**FEDERAL AVIATION ADMINISTRATION  
AIRWORTHINESS DIRECTIVES  
SMALL AIRCRAFT, ROTORCRAFT, GLIDERS,  
BALLOONS, & AIRSHIPS**

**BIWEEKLY 2004-17**

**2004-16-15 Eurocopter France:** Amendment 39-13771. Docket No. FAA-2004-18850; Directorate Identifier 2004-SW-19-AD.

Figure 1

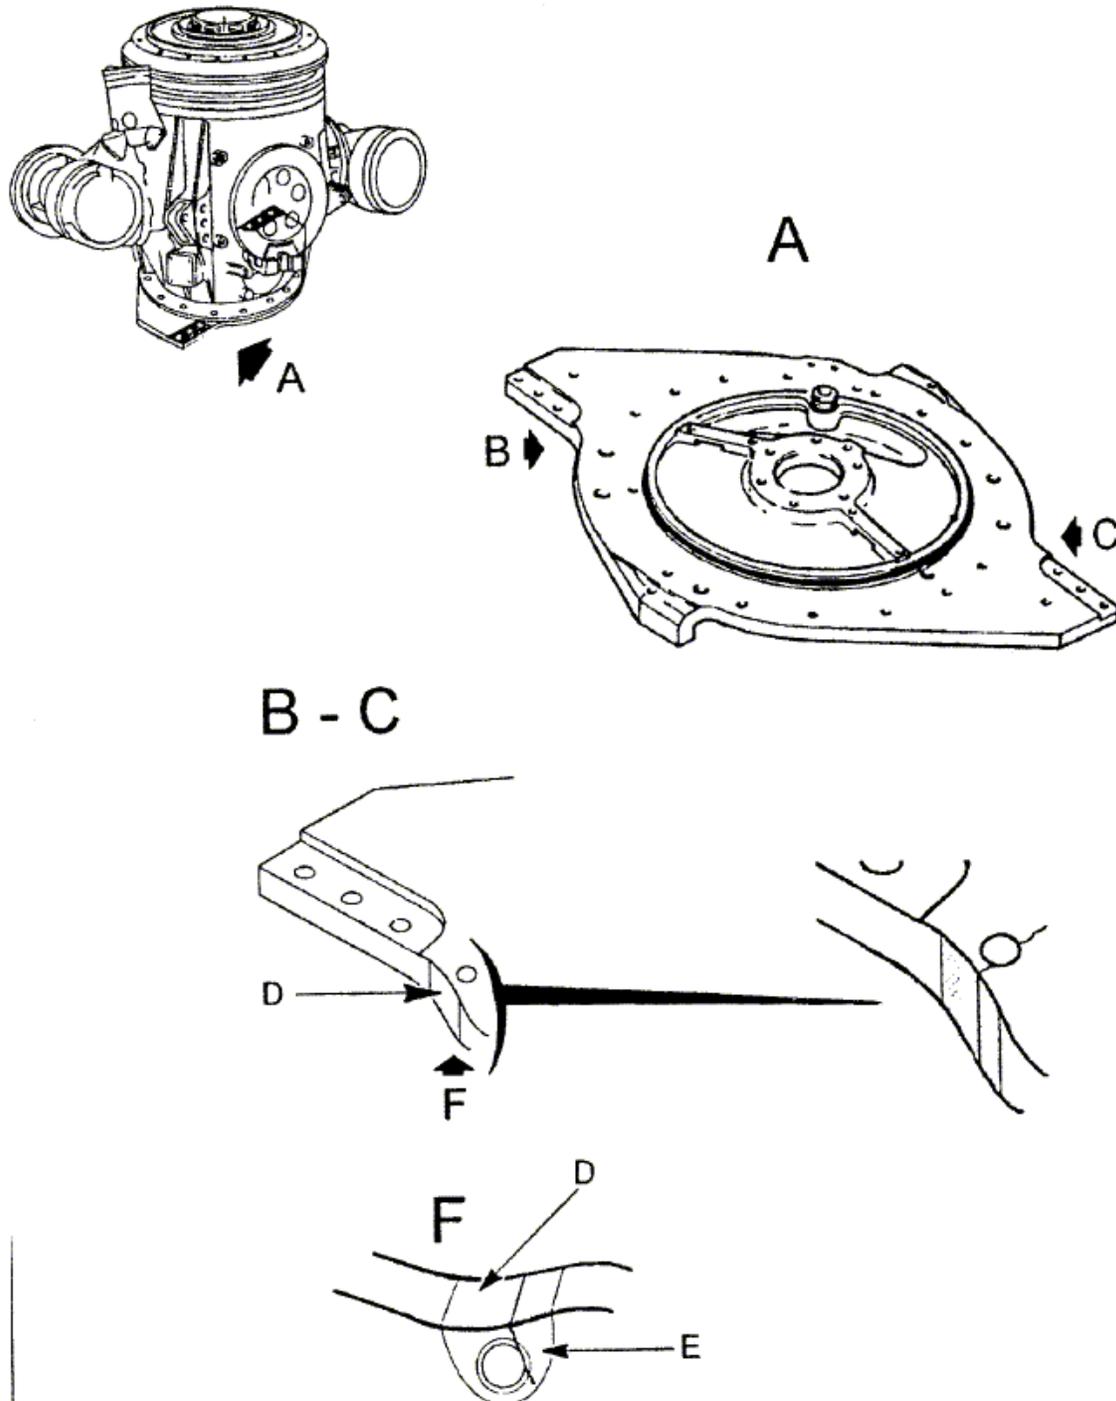
(a) Before the initial inspection at the time indicated in the compliance table, strip the paint from area "D" on both sides ("B" and "C") of the MGB base plate as depicted in Figure 1.

(b) At the times indicated in the compliance table, inspect area "D" of the MGB base plate for a crack using a 10x or higher magnifying glass.

(c) If a crack is found in a MGB base plate, remove and replace the MGB with an airworthy MGB before further flight.
